PARTS & SERVICE NEWS

REF NO.	AA98134
DATE	Sept. 14, 1998

SUBJECT: NEW I/P SHAFT BEARING ON T/M

APPLICATION: GD825A-2 Motor Graders, S/N 10001 thru 12036

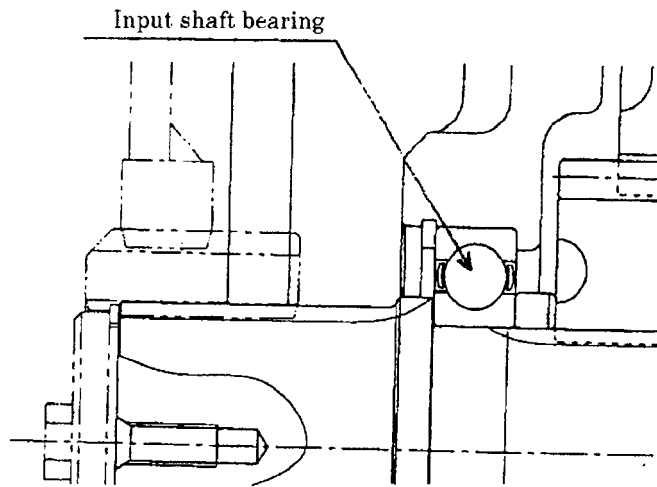
The input shaft bearing illustrated above have been improved.

Current Part
06040-06214

Improved Part
235-15-23310

(Although the improved part is of the same size as with the current input shaft bearing, we have improved its strength by changing the heat treatment method.
